**FINAL FINDINGS AND DECISION BY THE DESIGN
COMMISSION RENDERED ON August 6, 2015**

**CASE FILE NUMBER: LU 15-116838 DZM
PC # 14-228796**

Modera Belmont

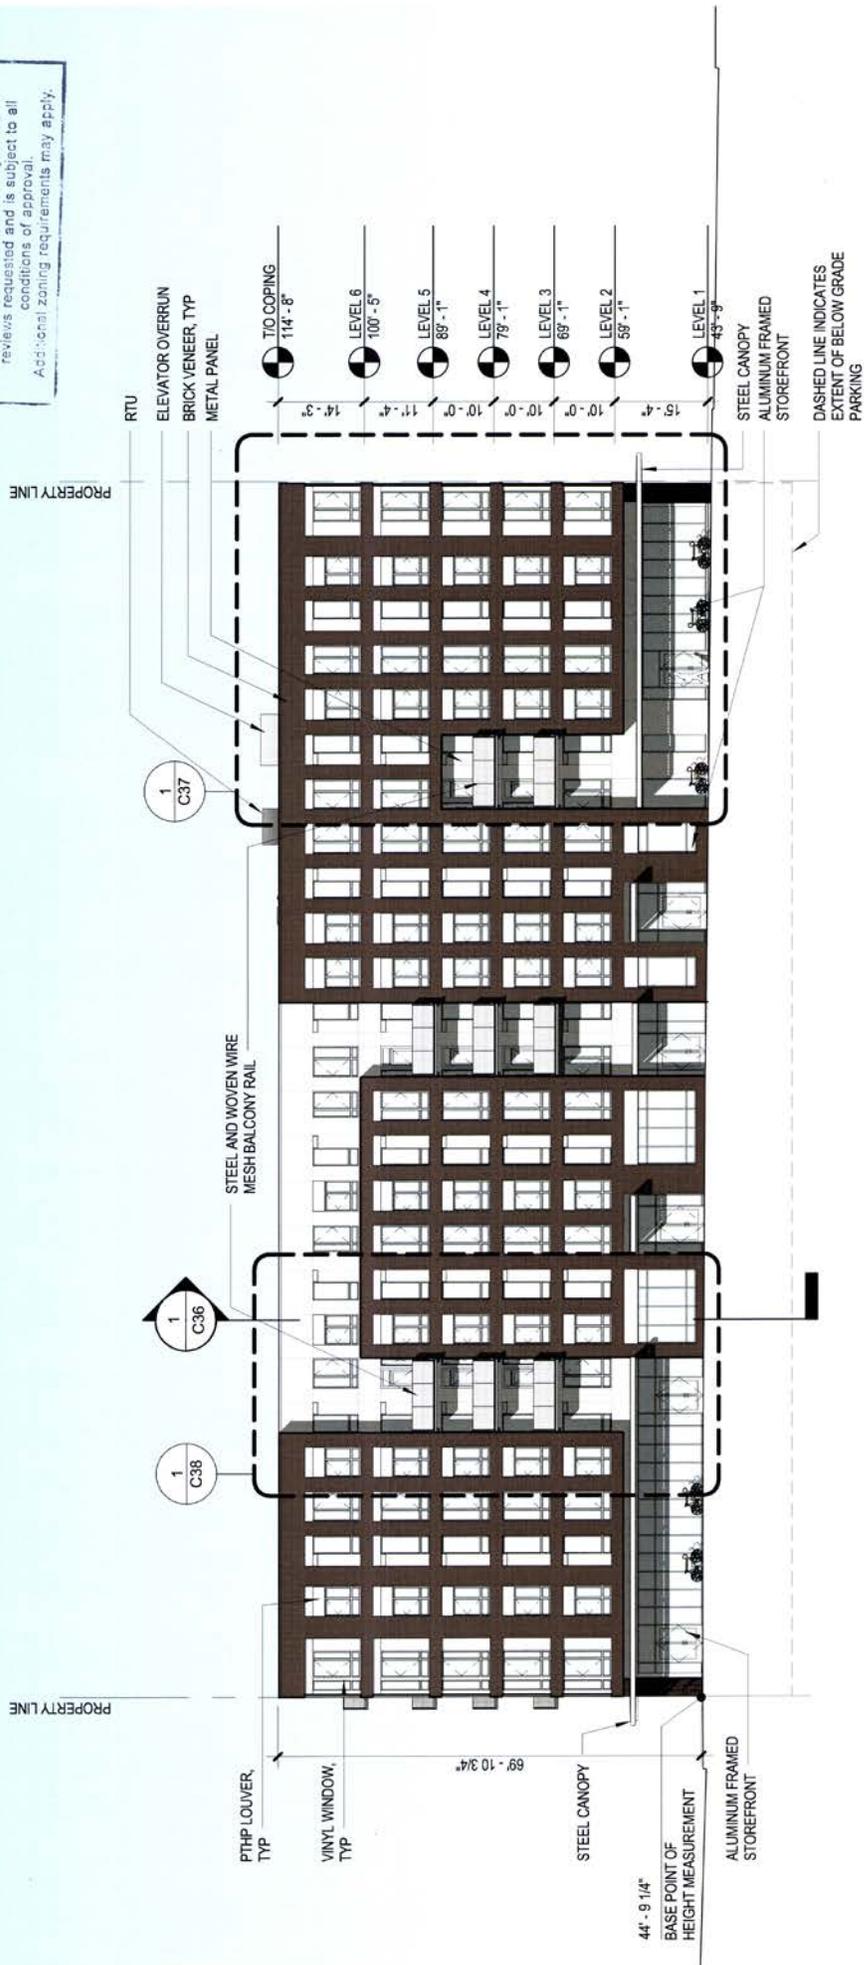
SEE COA D. FOR STOREFRONTS.

- D.** For the ground floor storefront system, the mullion spacing is to be increased from 3' in width (as shown) to 5' to better complement the proportions of the 5' wide window bays on the upper façade.

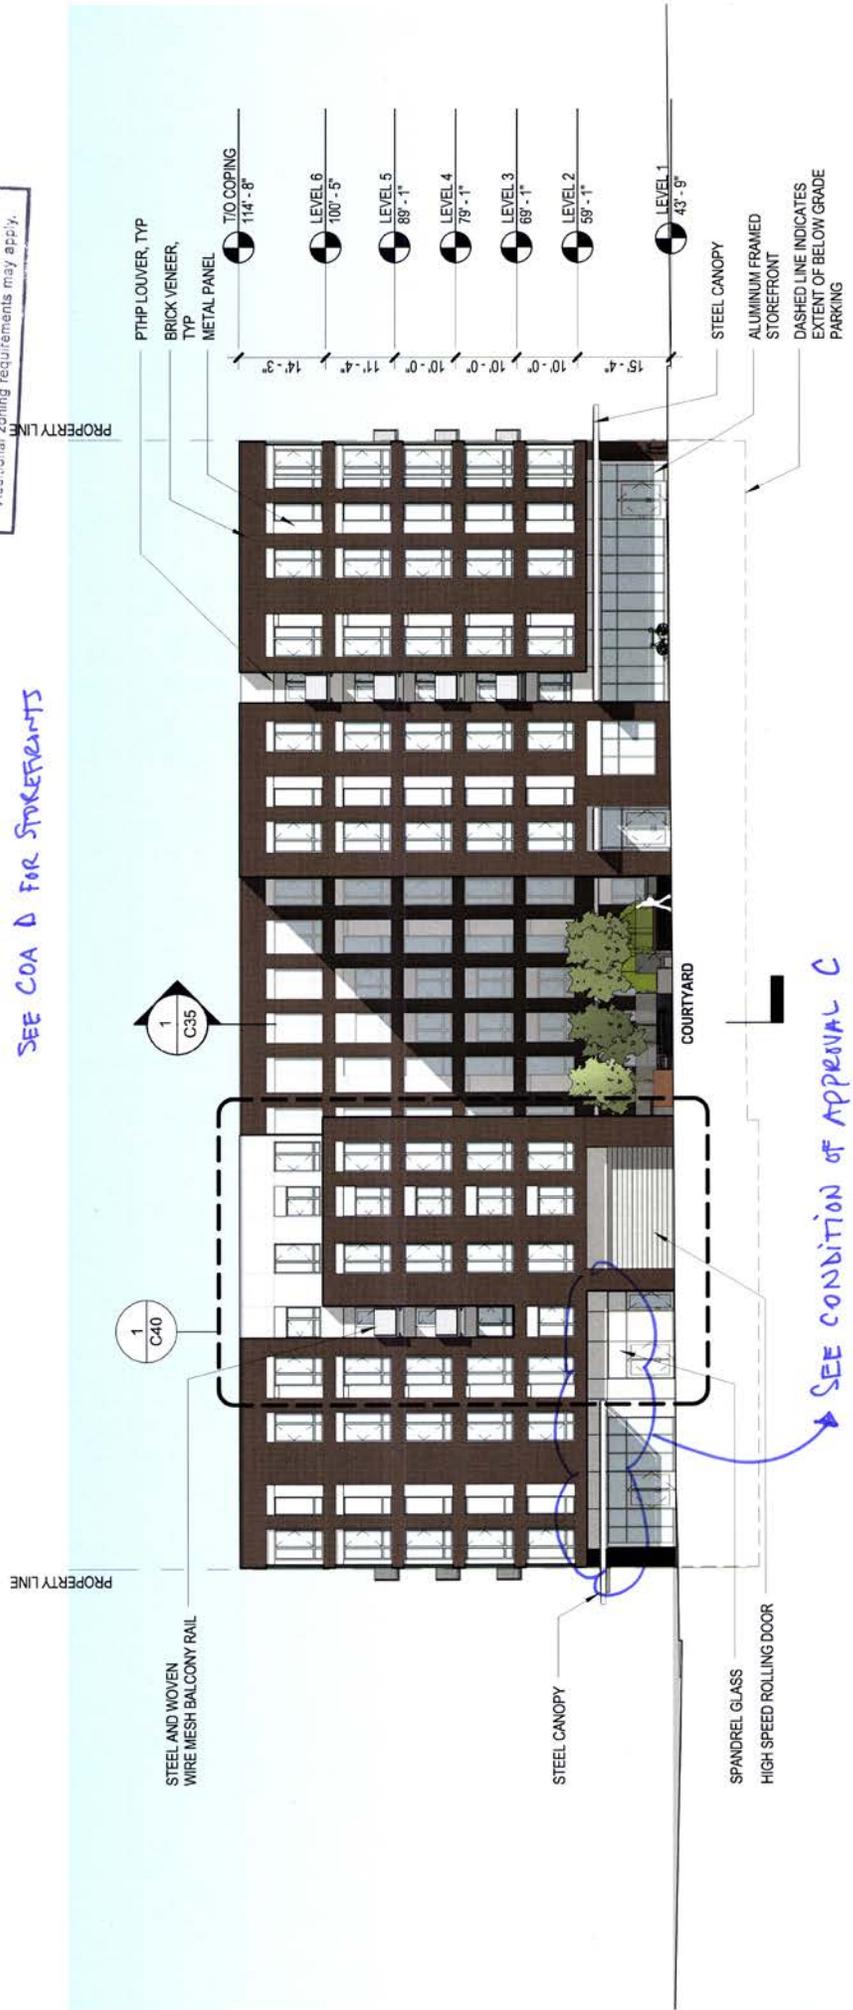
SEE COA D FOR STOREFRONTS
